**SOAH DOCKET NO. 582-15-2082
TCEQ DOCKET NO. 2015-0069-MSW**

Caldwell County's Prefiled Testimony and Exhibits

DIRECT PREFILED TESTIMONY OF TRACY BRATTON

EXHIBIT E

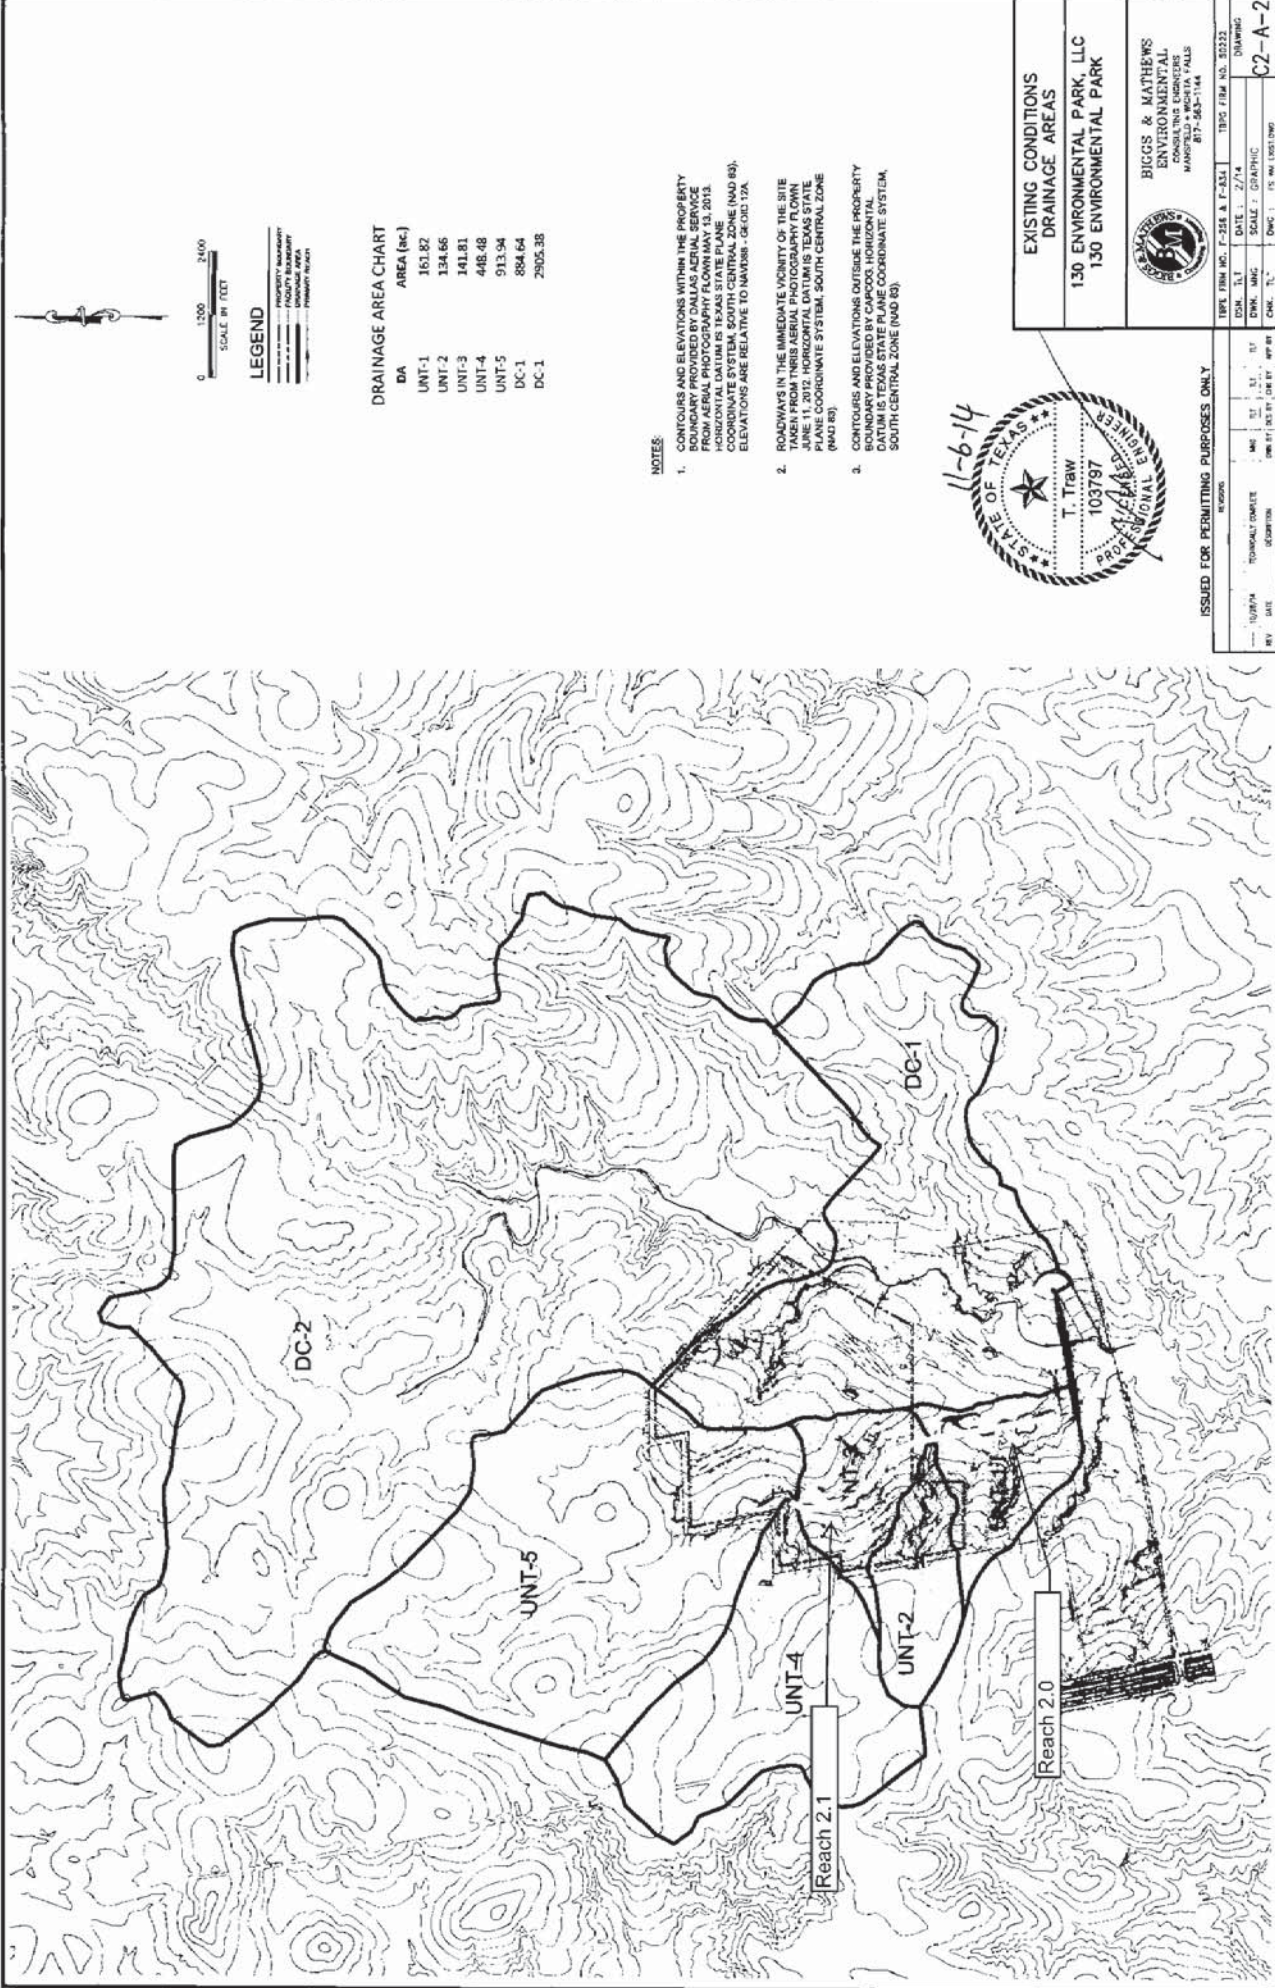
14 A: I have marked the location of Reach 2.0 and 2.1 on the applicant's drawing IIA.2 and it is
15 attached as Exhibit E, which is a true and correct copy of general topographic map and
16 existing drainage area map submitted with Application that includes notations by me
17 Reach 2.0 is the unnamed stream segment between the Site 21 dam and where the basin
18 UNT-2 joins the stream. Reach 2.1 is the continuation of the same unnamed stream to the
19 north until where flows from basins UNT-4 and UNT-5 converge.

1 values, of 0.045 for Reach-2.0 and Reach-2.1. The Applicant assumed a roughness
2 coefficient of 0.065 in these reaches, when a value of 0.045 would have been more
3 appropriate.

6 A: The Manning's n value is a parameter that reflects the roughness, or resistance, to water
7 flow, in this case in a stream. The higher the Manning's n the greater the resistance and
8 the slower the flow. Artificially low Manning's n value will reduce the speed in the stream
9 and increase the time of concentration, the effects of which I discussed previously. The
10 applicant did not supply calculations supporting their Manning's n assumption. Lacking
11 specific justification or analysis supporting a higher value, we requested they use 0.045
12 when reviewing the existing conditions modeling as part of their preliminary plat
13 documentation to Caldwell County. This value of 0.045 is an appropriate Manning's n for
14 small natural streams that are winding, weedy, and include ineffective areas or areas of
15 pooling. In addition, as an engineer you should justify your assumption or make an
16 assumption that is protective or conservative. Assuming a value of 0.065 results in a less

SIDESLOPE SWALE DETAIL

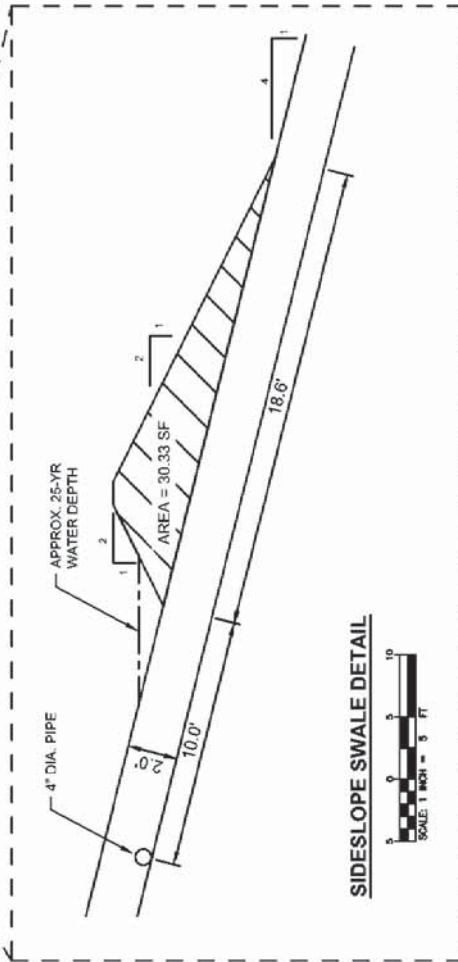
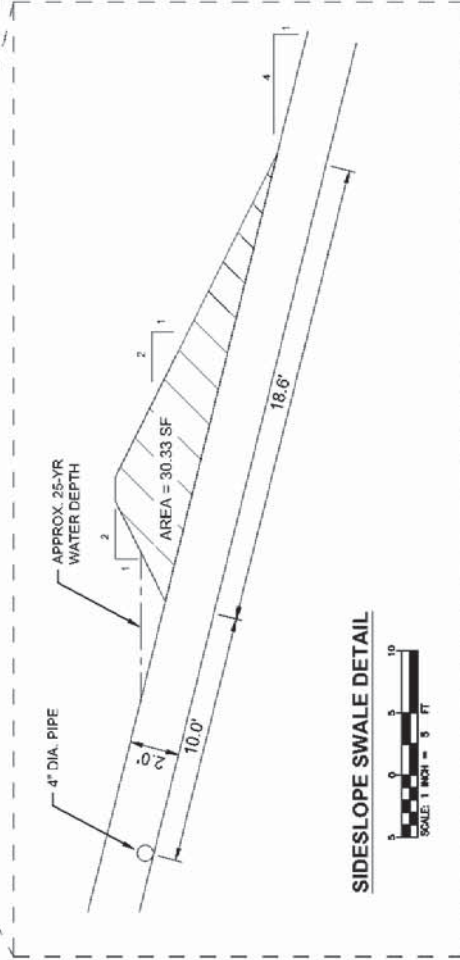
4 A: No. There is also no analysis provided that shows these diversion berms sloped at 2:1
5 perched on top of a landfill cover sloped at 4:1 are locally stable. In other words, no
6 separate analysis is included of these berms to show that they are not subject to a localized
7 slope stability failure.

12 A: The application does not contain specifics of how these will be constructed. Of particular
13 concern is the prospect that these berms may be constructed after the landfill cover. If
14 these berms are built on top of the 4:1 slope with no special consideration, the plane
15 between the landfill cover and the berm, in other words the joint where the original 4:1
16 cover and the berm meet, may become a pathway for water seepage and increased potential
17 for slope failure along this plane.

3 A: Drawing C3-19 includes a typical detail of the sideslope swale. On this detail it shows a
4 perforated drain pipe that will relieve water from the drainage layer between the landfill
5 cover and the flexible membrane liner. The detail is not drawn to scale but includes a
6 dimension of 10 feet from the flowline of the sideslope swale to the drain pipe. The detail
7 misrepresents the relationship between the drain pipe and the flowline of the swale. In
8 Exhibit F, which I created, this relationship is drawn to scale. The drain pipe is actually
9 higher than the flowline of the sideslope swale. Therefore, any water infiltration from these
10 sideslope swales will travel either along the joint between the berm and the landfill cover
11 or through the landfill cover down gradient to the next drain pipe.

14 A: These berms warrant separate analysis of their slope stability since they are 1) very steep
15 at 2:1, 2) subject to higher velocity concentrated stormwater flow at the upstream toe, 3)
16 also subject to soil saturation of their upstream toe due to their function as stormwater
17 conveyance structures, 3) no detail is provided as to how these berms will be constructed
18 to ensure there is no a failure plane between the landfill cover and the berm, and 5)
19 represent a large portion of the landfill face.

EXHIBIT H

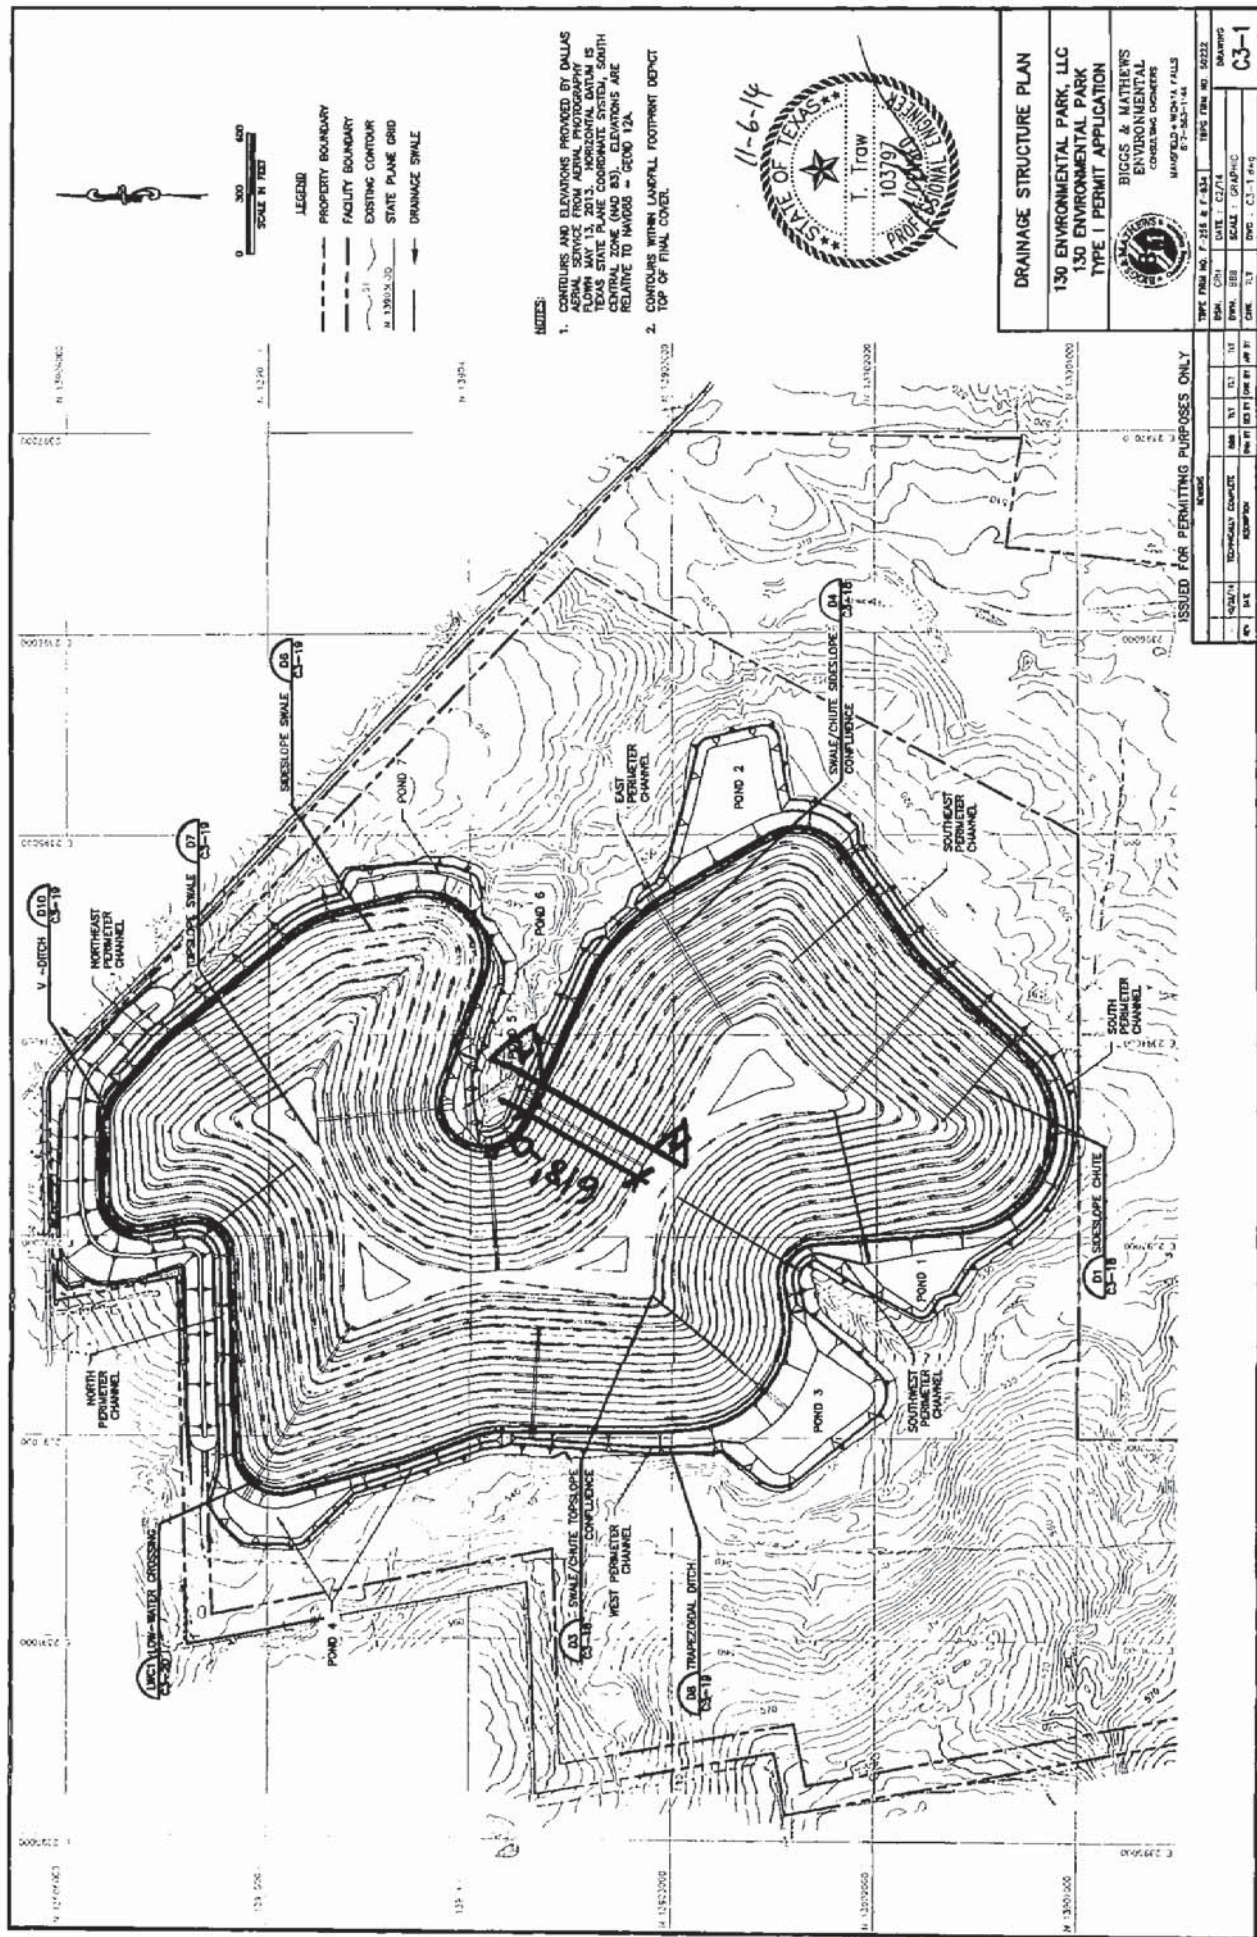
1 create these swales consume. Exhibit H, which is a true and correct copy of the Drainage
2 Structure Plan submitted with Application that includes notations by Tracy Bratton that
3 Demonstrates location of the cross-section in Exhibit F, which I developed to show where
4 on the landfill this cross-section is located.

3 A: In the drainage Structure Plan, illustrated in Drawing C3-1, at page 449 of Applicant's
4 Exhibit 130EP-2, shows that the sides of the landfill will include numerous swales intended
5 to divert stormwater. As shown on that page3, the design calls for approximately 12 or
6 more of these swales that will encircle the sides of the proposed landfill. The typical
7 dimensions of these sideslope swales are shown in Drawing C3-19, which is page 467 of
8 Exhibit 130EP-2. As shown on this figure, each swale will be two feet in height above the
9 landfill cover.
